**Moreland**  
City Council

## **COUNCIL AGENDA**

## 5.1 145 GLENLYON ROAD AND 6 PITT STREET, BRUNSWICK - PLANNING APPLICATION MPS/2020/260

## 5.2 11-15 BRUNSWICK ROAD, BRUNSWICK EAST - PLANNING APPLICATION MPS/2014/1048/C

#### ***Setbacks to Residential Land***

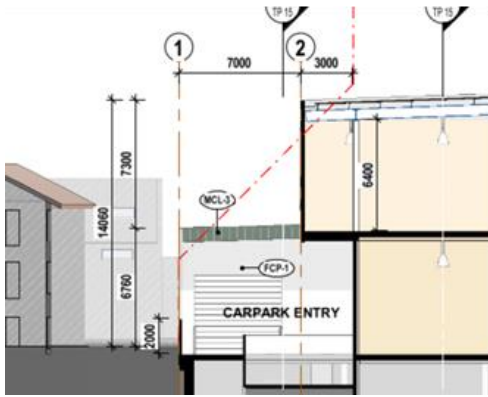
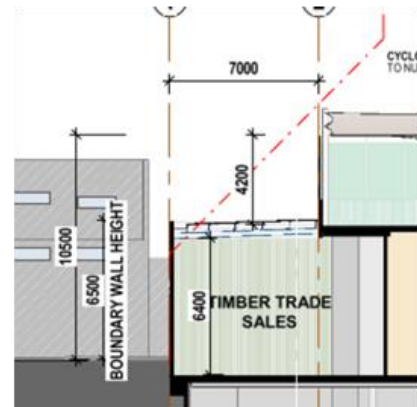
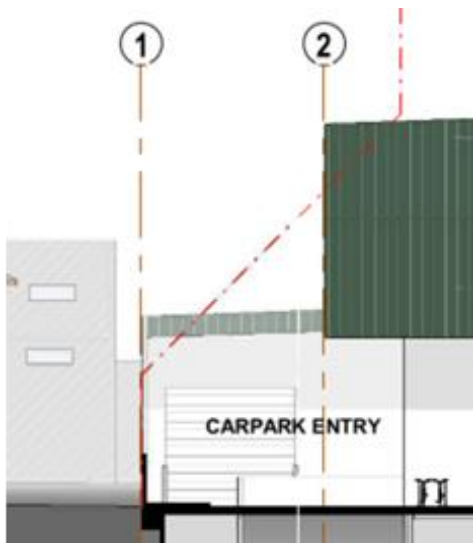
The residential properties to the west of the site are zoned Neighbourhood Residential and are outside of the Brunswick Activity Centre. While parts of the development comply with the setbacks specified in DDO19, the height of walls on the western boundary and parts of the first floor encroach into the required setbacks from residential land. The diagrams below depict the required setback in red to demonstrate where the proposed building encroaches into this setback. While the eastern side of 133 Glenlyon Road is predominately used for vehicle access, 2A and 2B Loyola Avenue have private open space areas on the eastern side of the buildings. Were a permit to issue, the parts of the development that are adjacent to secluded private open space areas of adjoining dwellings and encroach into the specified setbacks could be conditioned to comply with the DDO19.

**Figure 3: DPO12 Concept plan**

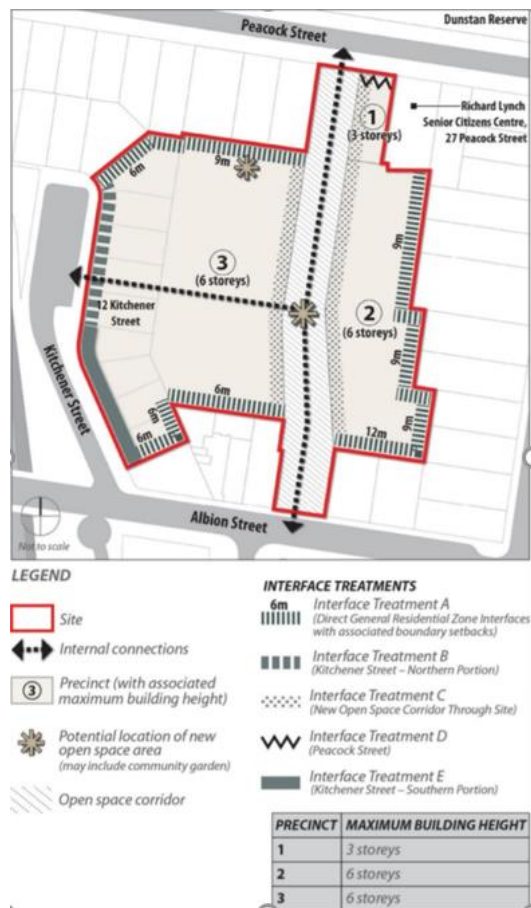
The Development Plan meets the DPO12 height requirements. The proposed buildings will be spread out throughout the site with the lower built form (three storey townhouses) constructed at the residential interfaces to the north, south and west thus, minimising offsite amenity impacts. The variations in the heights assist in reducing the visual bulk and dominance of the buildings as perceived from the public realm.

- Building B: Level 6 balcony balustrade and parapet encroach into east setback. Refer to Figure 2 below.
- Building C: Level 6 balcony balustrade encroach into east setback and parapet encroach into south setback.

**Figure 5: Cross section showing proposed landscaping above basement. The plan fails to provide information relating to soil volumes and depth and shows limited space for soil above the basement.**

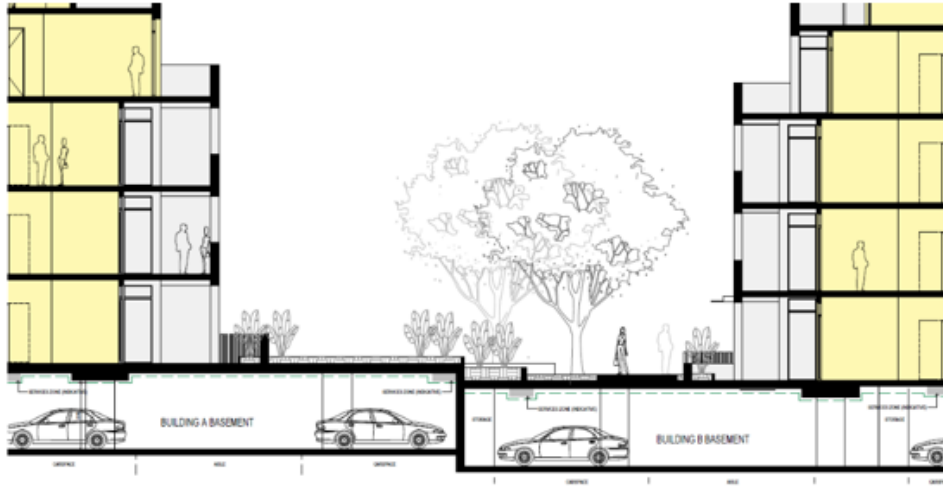
Council's Urban Forestry officer has raised concerns with the viability of the landscaping within the open spaces, which are proposed above a basement car park, and has recommended provision of adequate soil volumes and containers for successful landscaping. This forms a condition of the recommendation. This may require the basement to be lowered, in order to provide sufficient soil volumes. Large at-grade planter-boxes should not be supported, as these would impact both the useability of and clear sightlines through the pedestrian corridor.
